Commonwealth Edison
One First National Plaza, Chicago, Illinois
Address Reply to: Post Office Box 767
Chicago, Illinois 60690

Subject: Byron Generating Station Units 1 and 2
Integrated Design Inspection
Inspection Report 50-454/83-32
NRC Docket Nos. 50-454 and 50-455

Attachment A
Byron IDI Report Response

FIGURE 1

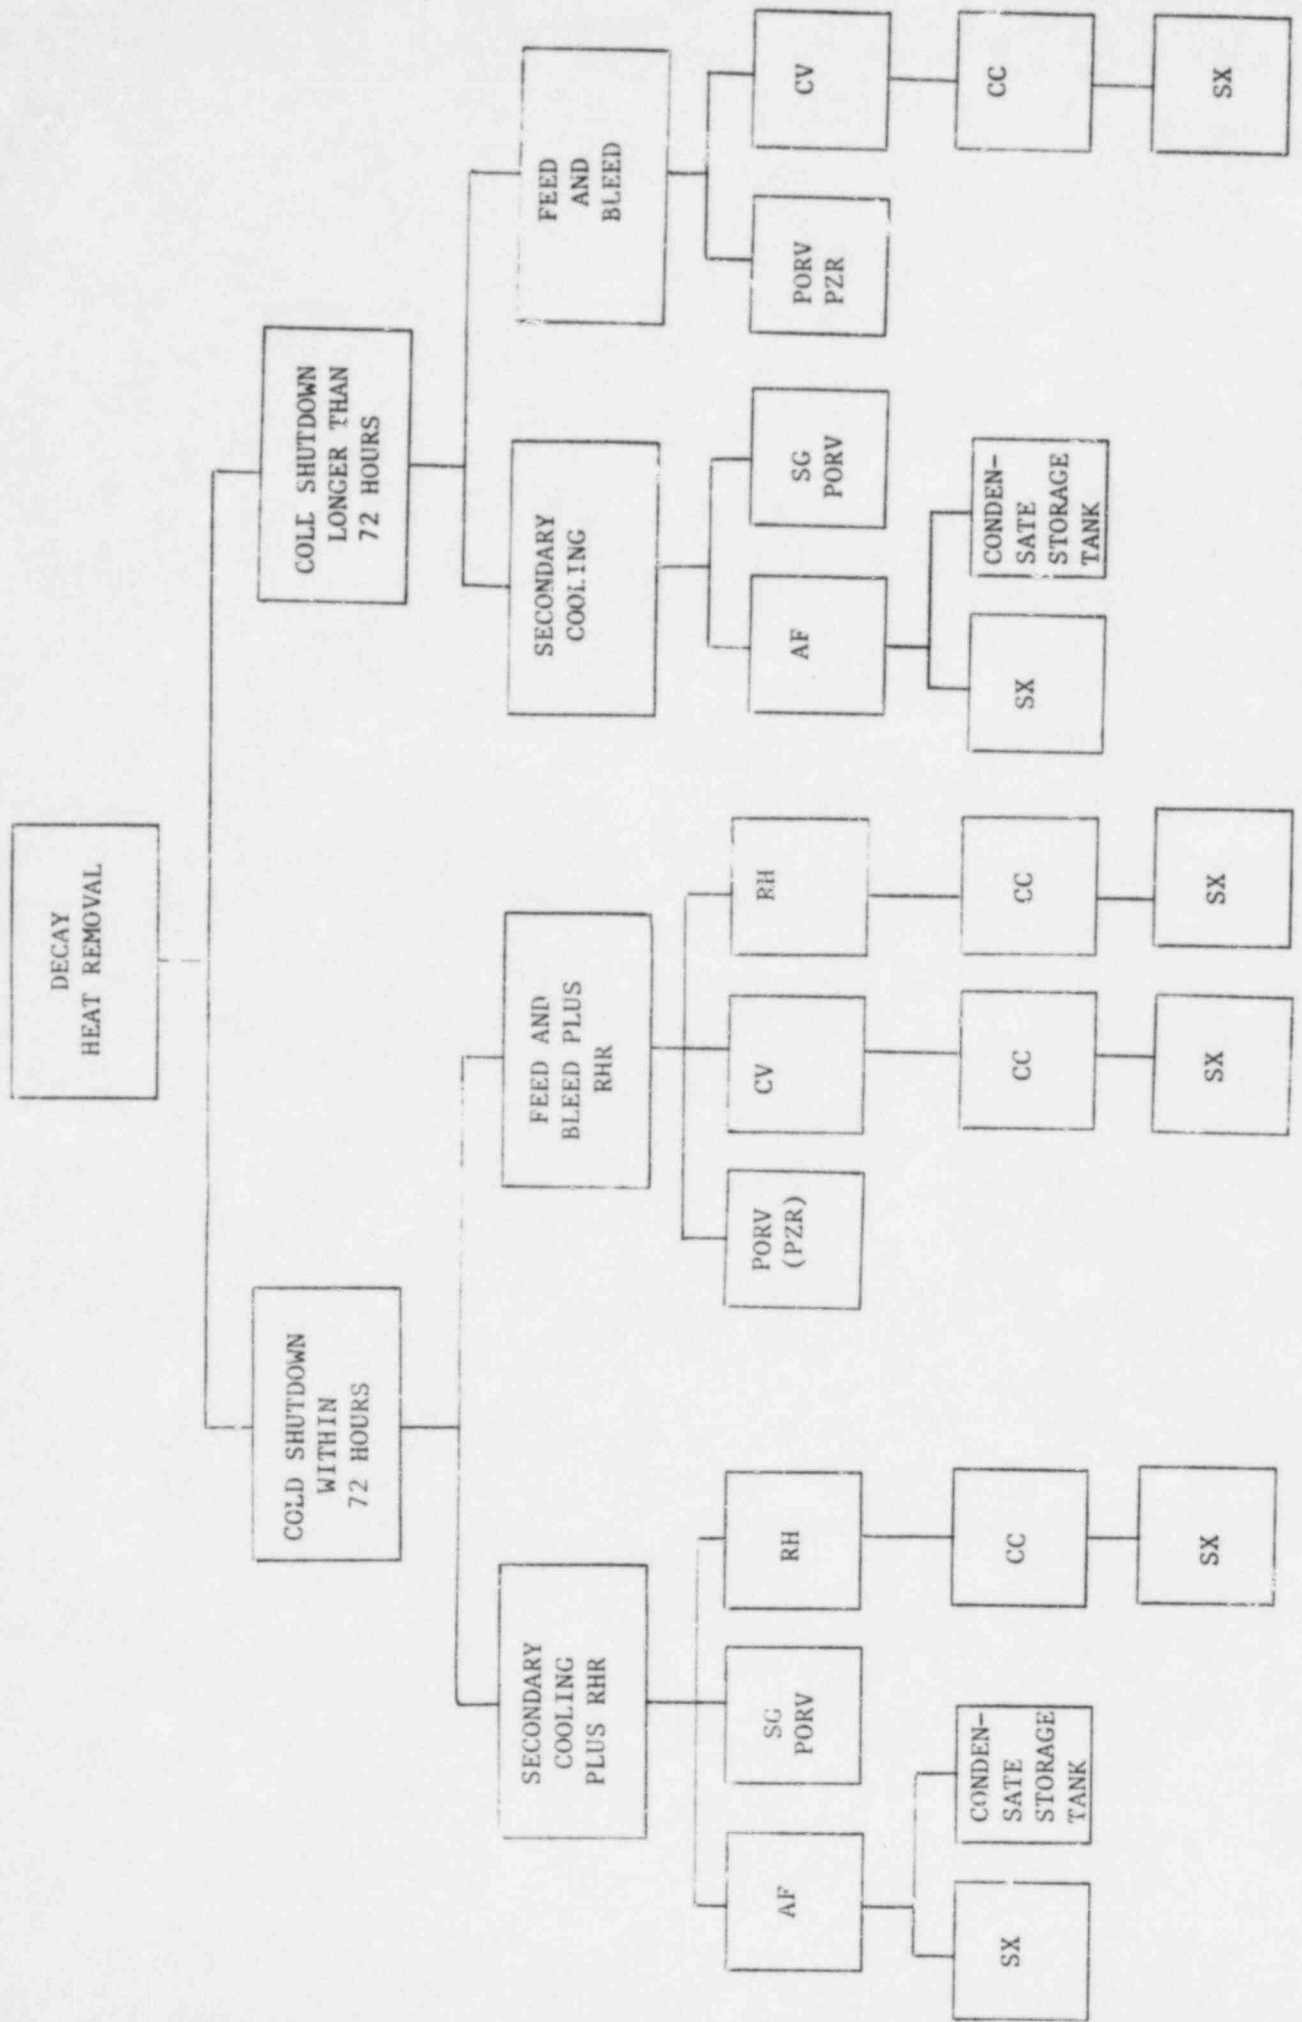
We do not agree with the conclusions of this finding because they misinterpret the FSAR commitment and disregard the methodology actually used to evaluate the effects of moderate energy pipe cracks. This methodology (briefly discussed below), which is very conservative and exceeds the FSAR commitments, was explained in detail to the IDI Team but is not mentioned in Section 2.4.4 (Moderate Energy Pipe Cracks) of the IDI Report.

The function and redundancy of these systems can best be seen by examining a diagram of the various paths for safe shutdown decay heat removal as shown in Figure 1. This diagram shows four paths. Two of these reach cold shutdown within 72 hours while the other two (without RHR) may take longer than 72 hours. These paths assume offsite power has been lost.

As shown in Figure 1, the RH system is required only to reach cold shutdown in a short time. The only RH component outside containment which could be affected by spray is the RHR pump motor. This motor is located in a room adjacent to the containment which contains only one train of the RH system. As a result, any crack which causes failure of one RHR train will not require postulation of a single failure in the redundant train.

The essential portion of the CV system consists only of the charging path into the containment. The valves in this path are normally open and fail in that position. The pumps are in cubicles separated from the redundant train and other systems. In the event one centrifugal charging pump fails and the other is disabled by a single active failure, the CV system is backed up by the Safety Injection System. The SI system becomes available when the primary system pressure is reduced to 1700 psig and is not subject to common failure with the CV system. Secondary cooling (per Figure 1) is used to reduce the primary pressure.

The AF system has no components which could be damaged by spray, except for the pump drives. These are in rooms which contain only one AF train. Therefore, water spray will affect only one train of the AF system. The reliability of the AF system has been documented in the response to NRC Question 10.53 and accepted by the NRC. In the event spray disables one AF train and single failure disables the other, safe shutdown can be achieved per Figure 1 by feed and bleed of the primary system with or without RHR.
